PRELIMINARY/ FINAL LAND DEVELOPMENT PLAN FOR

REPLER INVESTMENTS LP.

CENTRAL PA SWEEPERS

Re: 380 Hershey Road (Repler Investments L.P.)
Preliminary/Final Land Development Plan
Township Permit No. 23-05-FLDP
LCEC Project No: 25-135

| MARK | REVISIONS | DATE | REPLER INVESTMENTS, LP. MOUNT JOY TOWNSHIP LANCASTER COUNTY, PENNSYLVANIA | |
|--------------|-------------------------------|-----------|--|---------------|
| FILE NAME: | | 8262202 | | SHEET 4 of 13 |

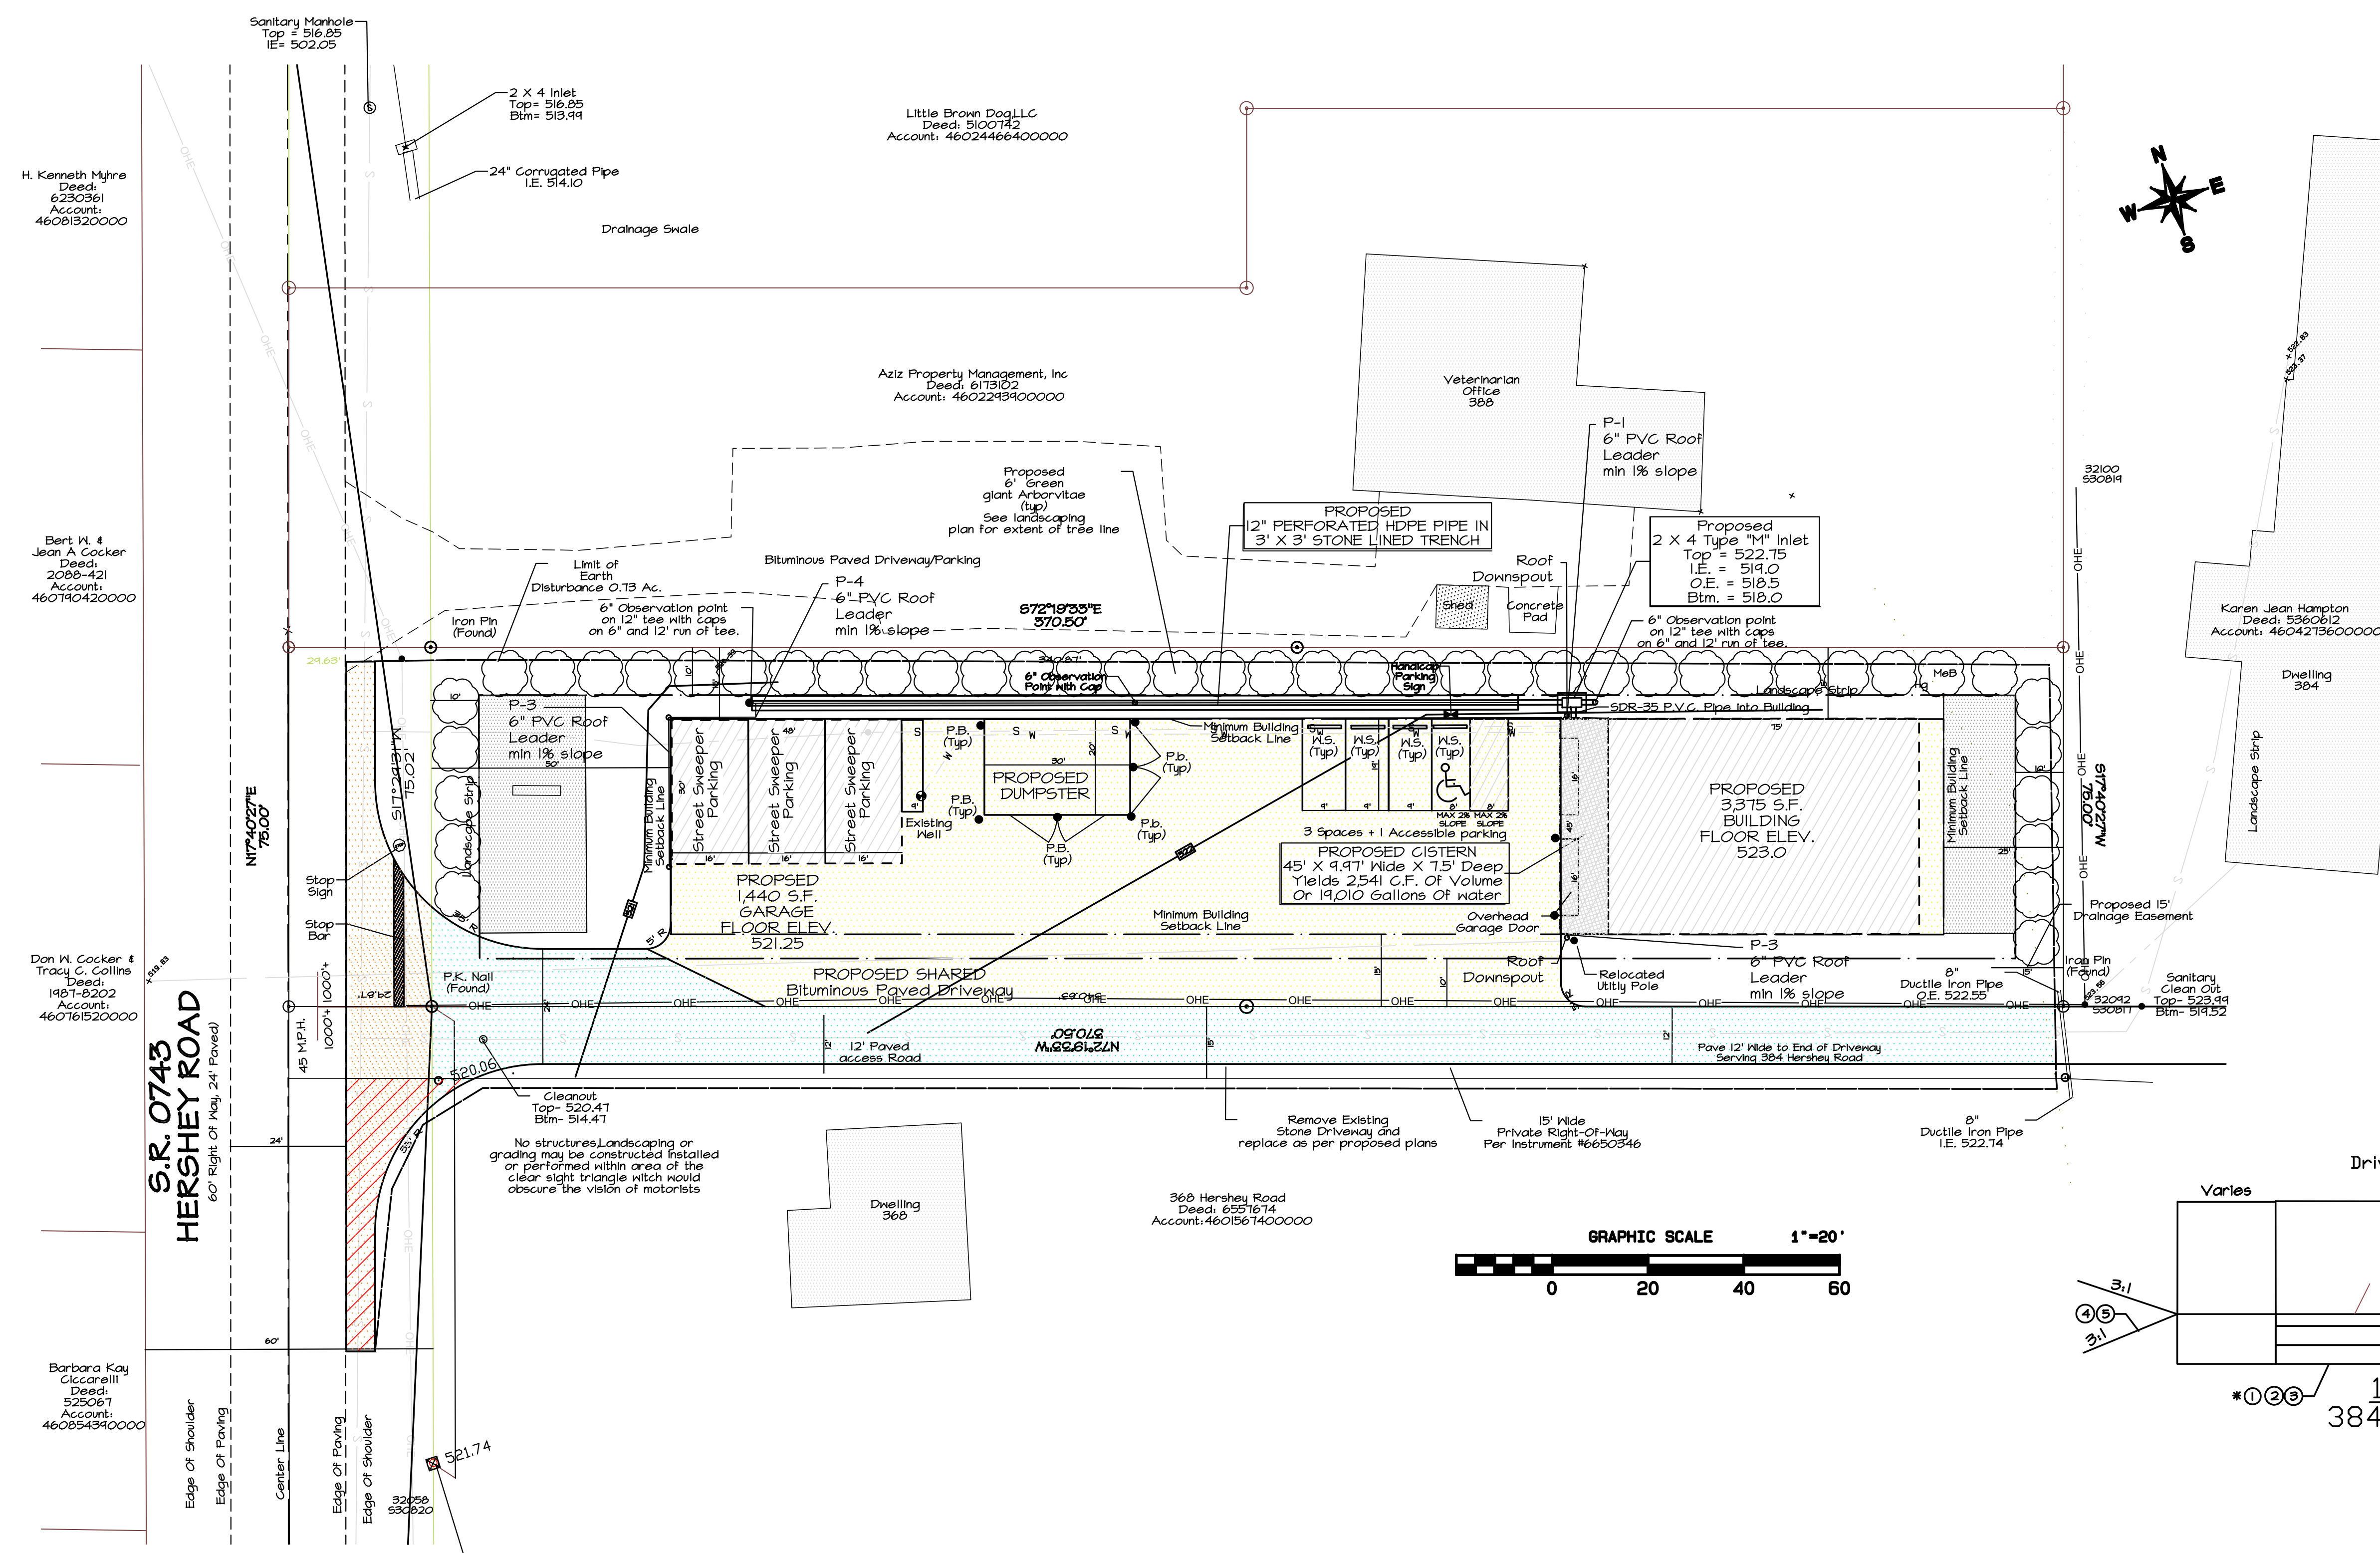
41. The names of the roof leaders (i.e. P-3) shown on Sheet 4 of the plans shall be corrected (113-42.A).
42. The plans should provide spot elevations to the southeast of the proposed building to confirm the post-development drainage area boundaries to the cistern and post-development bypass drainage area (113-43.J(1)).

43. The designer shall clarify the meaning of the hatches on the eastern and western portions of the subject tract shown on Sheet 4 of the plans (113-43.J(2)).

46. The applicant should clarify the proposed design of the 6" Observation Point on 12" Tee With Caps on 6" and 12' Run Of Tee shown on Sheet 4 of the plans. The Stormwater Collector Trench Controls detail shows a 12" Cap and 12" Cap Cleanout on an elbow (113-43.J(5)).

| FILE NAME: _____ FILE DATE: _____ | SCALE: AS NOTED DRAWING NO. PCSM-1 FILE CODE: 8262202 SHEET 5 of 13 |

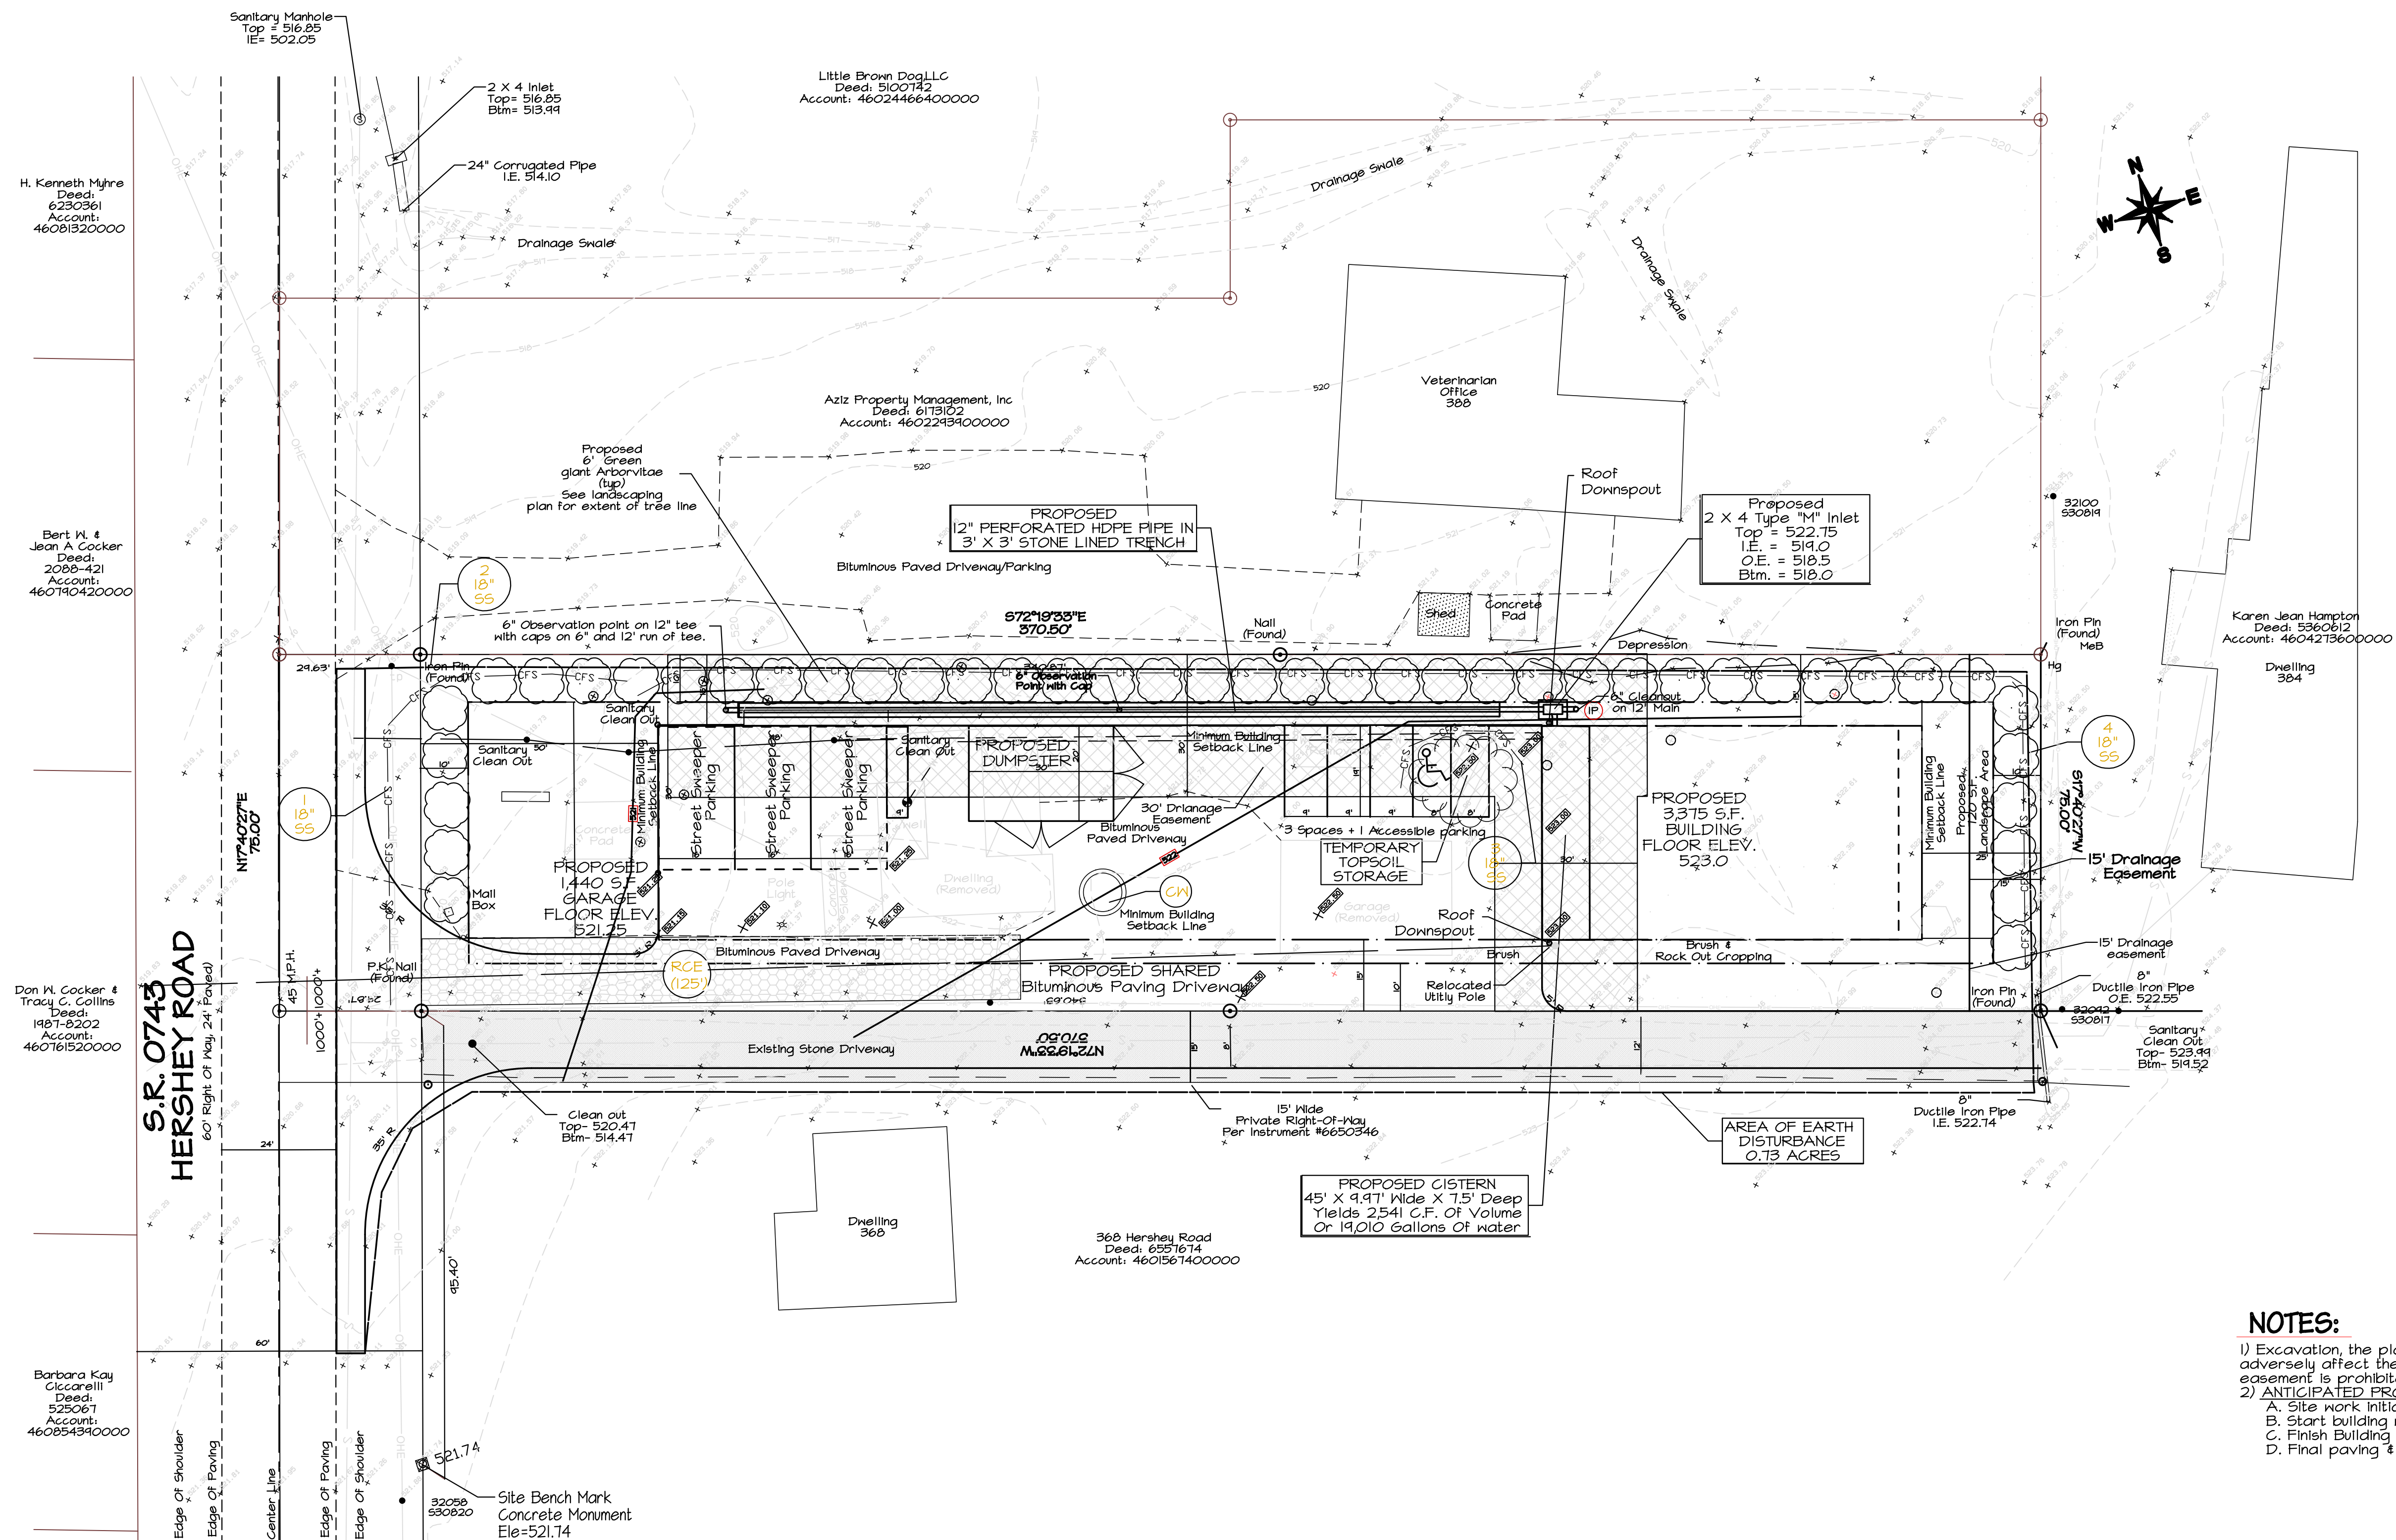
4. The linetype and linetype color of the right-of-way shown in the plan view is inconsistent with that shown in the legend (119-31.A(4)). The fence linetype shown in the legend on Sheet 5 is inconsistent with the fence linetype shown around the dumpster on Sheet 8.
5. Since Glace Associates has been acquired by the JHA Companies, the engineer shall confirm whether the name of the firm that prepared the plan needs to be updated (119-31.B(3)).
6. The plan shall identify all prior plans, including all notes or restrictions affecting the current development, with a verification signed by the design professional that such list is complete and correct (119-31.B(14) & 119-51.C).
7. A wetlands study shall be provided (119-32.B & 119-34.E(3)(c)). The applicant has requested a waiver of this requirement.

24. A minimum 30 foot wide access easement shall be provided for the stormwater facilities. The requirements in the Maintenance Of Drainage Easement note on Sheet 5 shall be included in the new deed. The applicant shall be responsible for completing a declaration of easement and stormwater management agreement in a form that is acceptable to the Township Solicitor (119-56.D, 119-56.E, 113-31.R & 113-31.Q).

- a. Design information, including calculations, shall be provided for compost filter sock #4 shown on the plans
- b. The "Anticipated Project Schedule" on Sheet 5 of the plans shall be updated.
